APPLICATION NO.	FILING DATE	FIRST NAMED INVENTOR	ATTORNEY DOCKET NO.	CONFIRMATION NO.
10/667,901	09/23/2003	Joseph Cargnelli	9351-244	8648
1059	7590	06/05/2006		
BERESKIN AND PARR 40 KING STREET WEST BOX 401 TORONTO, ON M5H 3Y2 CANADA			EXAMINER ALEJANDRO, RAYMOND	
			ART UNIT 1745	PAPER NUMBER
DATE MAILED: 06/05/2006

Office Action Summary

DETAILED ACTION

Fig. 3

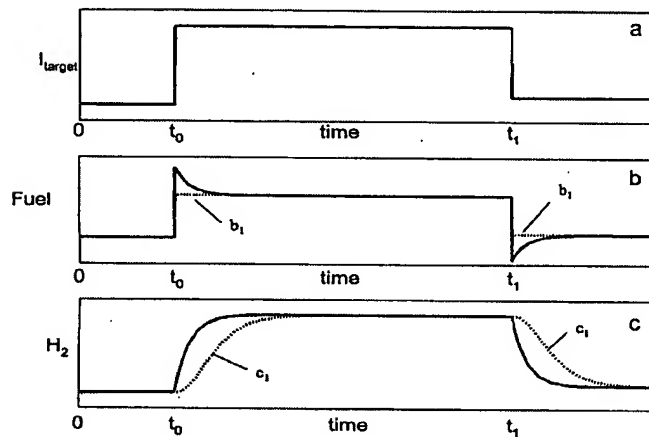
function of time to control and operate the fuel cell system (P. 0045-0046/ FIGURE 3). Thus, *Blum et al* specifically use a measured fuel cell operation characteristic to control another respective operation characteristic. That is to say, the another respective operation characteristic is responsive to the measured fuel cell operation characteristic as best understood by the examiner.

Figure 3 below illustrate the so-called relationship between the current demand and the flow of hydrogen:

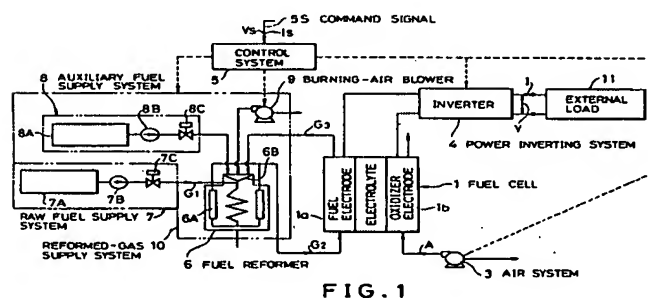
It is disclosed that the controller controls the system based upon or using measured values or calculated values of the mass flow of the hydrogen rich-gas (P. 0032). Of particular interest is that Blum et al employ a relationship between the current demand and the fuel mass flow as a function of time to control and operate the fuel cell system (P. 0045-0046/ FIGURE 3). *Thus, Blum et al readily envision using stored values as fuel cell operational threshold.*

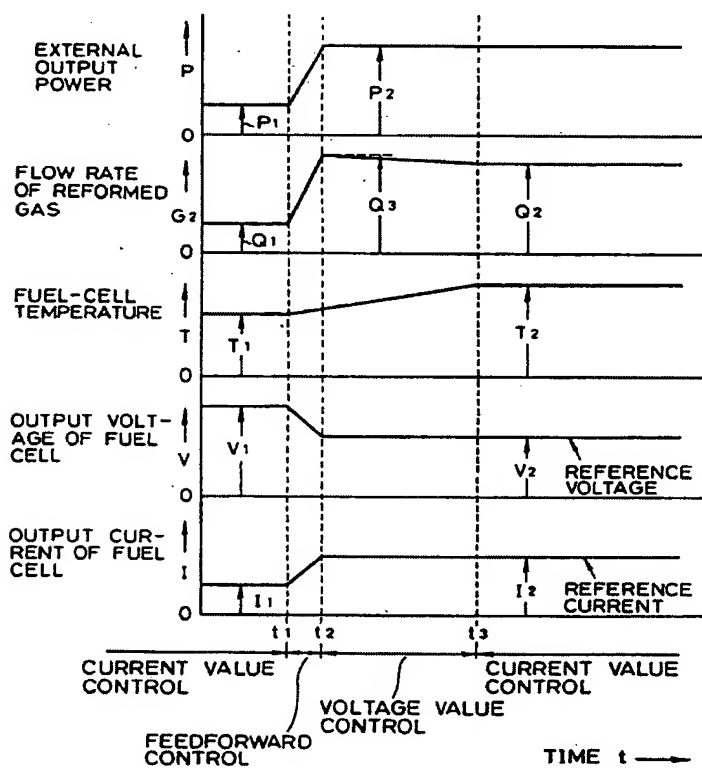
Harashima disclose method of controlling operation of fuel cell power supply (TITLE). Essentially, a fuel cell power supply in which the flow rates of reactant gases are set at a flow rates required for a steady state operation plus predetermined extra amounts when an output power increase command is issued (ABSTRACT). Harashima teaches supplying the power of the fuel cell to a load (COL 1, lines 30-32). The control of the entire system is accomplished according to control signals from a control system which receives a command signal that designates an output power of the fuel cell (COL 1, lines 32-35).

Figure 1 depicts a fuel cell system including a fuel cell 1; and control system 5 and reactant supply means peripheral:

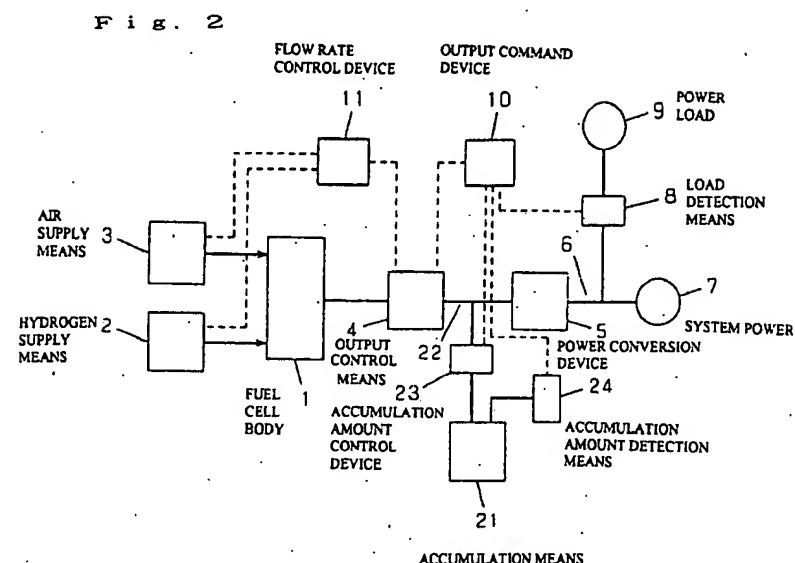
Disclosed is that at an external load command, a power control unit 35 controls a flow rate control unit 36 which controls the flow rate of the hydrogen supply by the hydrogen supply means (*the reactant supply means peripheral*) and the flow rate of the air supply by the air supply means 33 such that the flow rates can be optimum values; and the power converter controls the amount of electricity output by the fuel cell body, thereby successfully controlling the output power (P. 0228; 0002; 0009; 0021-0025). *Thus, Ueda et al show with sufficient specificity to control the flow rate of reactant in response to output power requirements.*

Figure 2 illustrates several features including the output control means; the load; the load detection means; the accumulation amount control device and the like.
